**OFFICE OF DESIGN POLICY & SUPPORT
INTERDEPARTMENTAL CORRESPONDENCE**

FILE P.I. # 0006889 **OFFICE** Design Policy & Support
CSSTP-0006-00(889)
DeKalb County
GDOT District 7 - Metro Atlanta **DATE** 7/9/2015
Lithonia Industrial Boulevard: I-20 to
Evans Mill Road - Phase III

SUBJECT APPROVED REVISED CONCEPT REPORT

REVISED PROJECT CONCEPT REPORT

LITHONIA INDUSTRIAL BLVD - PH III

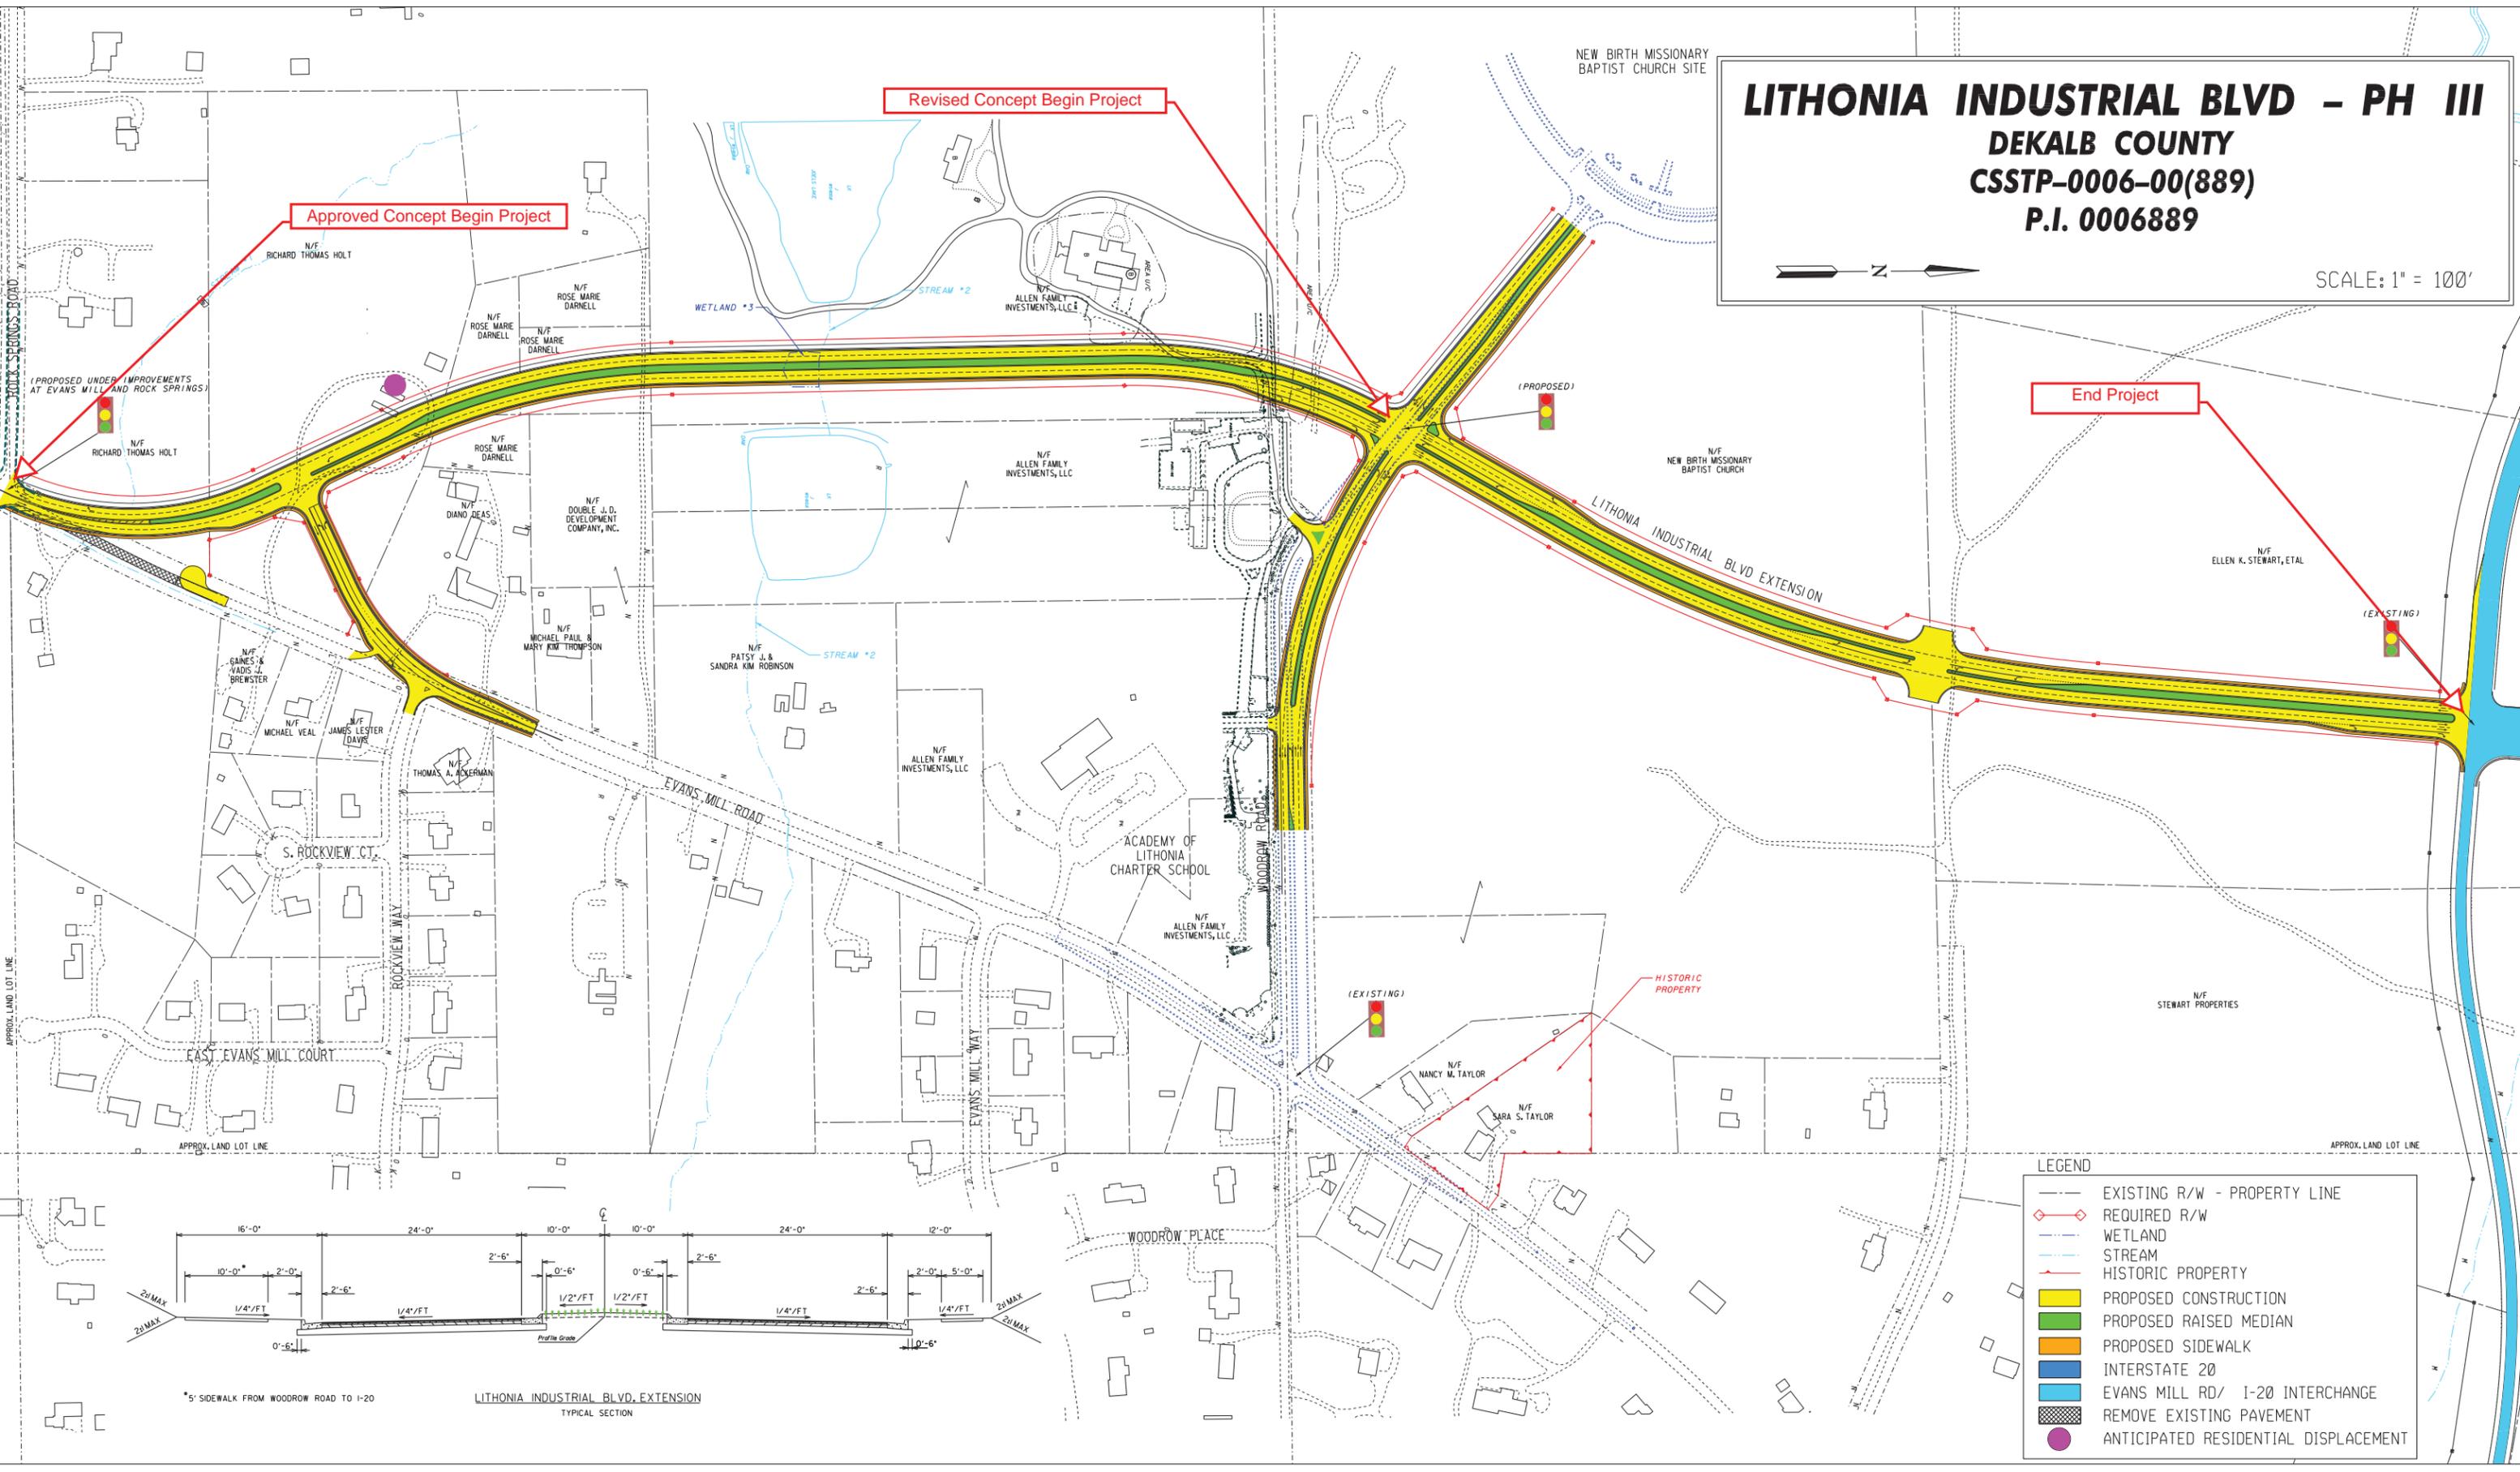
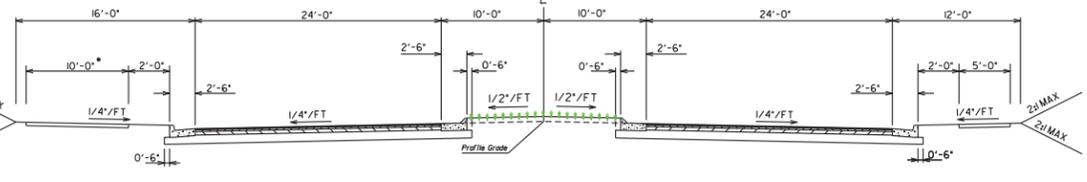
It is proposed to shorten the project limits by beginning the project at the intersection of Lithonia Industrial Boulevard (LIB) with Woodrow Road. The revised length of project would be 0.636 miles. The limits have been shortened to the intersection with Woodrow Road to keep the project cost in line with the available local funding. Beginning the project at Woodrow Road provides a logical terminus.

Approved Concept Begin Project

Revised Concept Begin Project
